CONSTRUCTION OF NEW MUNICIPAL SOFTBALL PARK REBID

PROJECT NO.: 08-18-C28-608

A D D E N D U M NO. 1

ADDENDUM No 1
SOFTBALL FIELD FACILITIES
MUNICIPAL PARK
McALLEN, TEXAS

ENLARGED PLANS

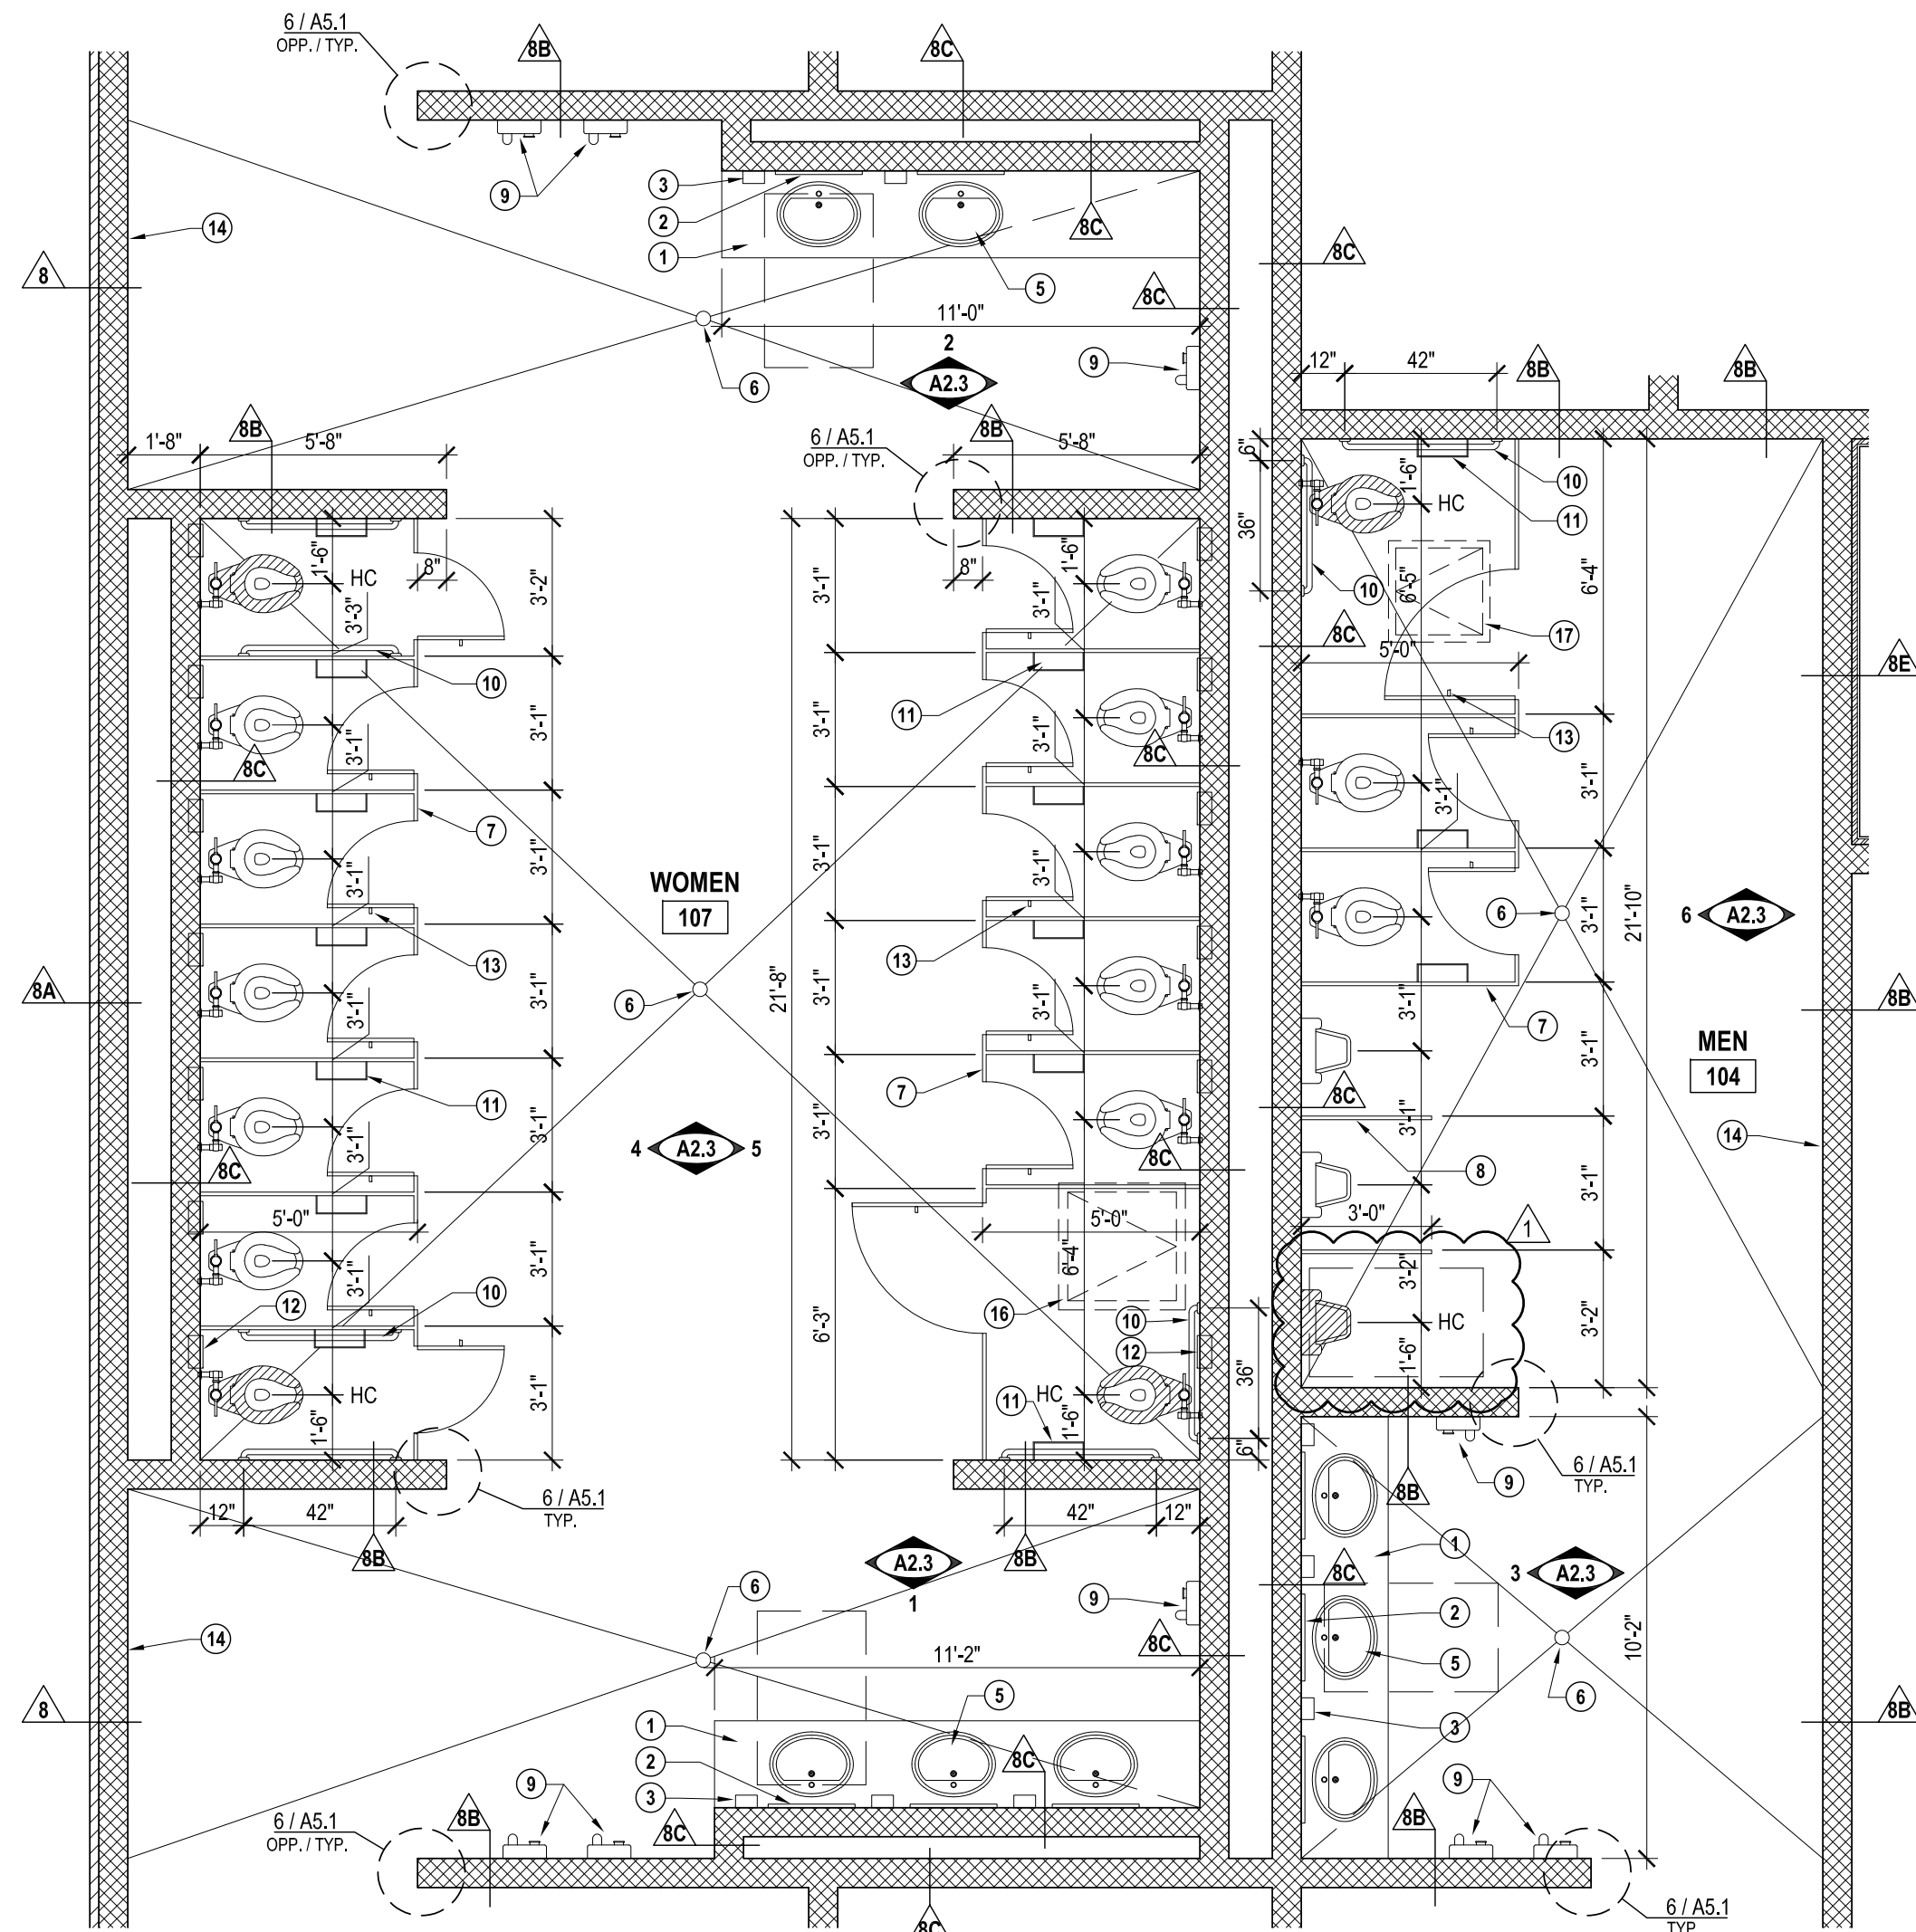
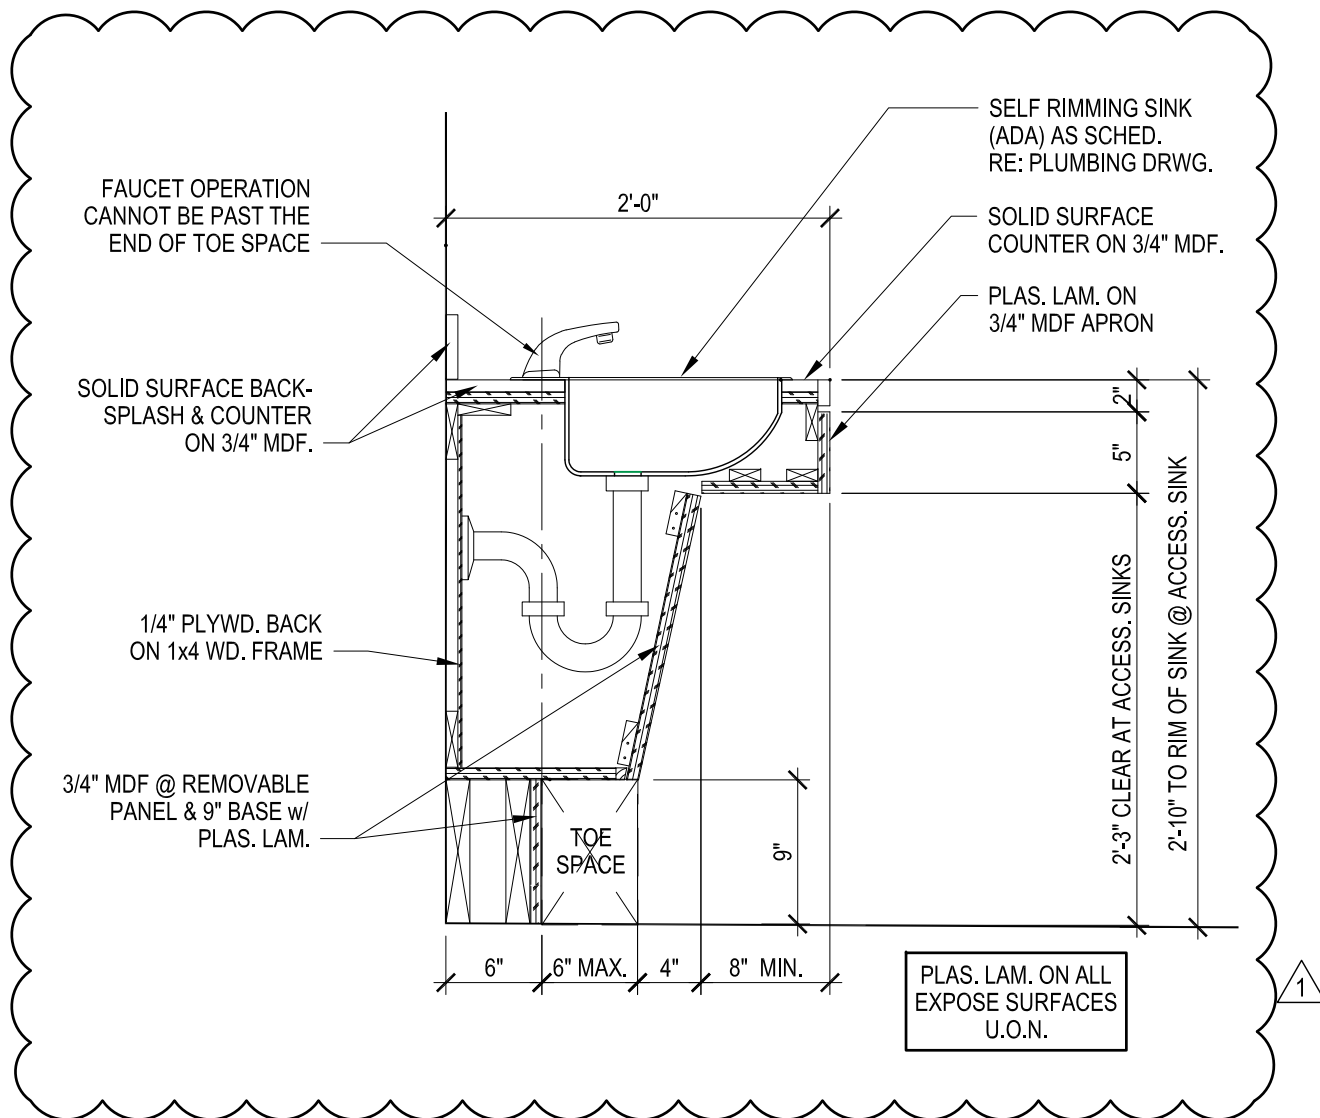
- A2.1 Added outline of Cupola wall above. Added RCP key note #7 & revised key note #8.
- A2.2 Relocated ADA urinal, added ADA notes & dimensions.
- A2.3 Relocated ADA urinal, added ADA notes & dimensions.
- A3.1 Added Cupola & material call outs.
- A4.1 Added wall section at Cupola. Added ADA notes & dimensions.
- A4.2 Added wall detail at Cupola.
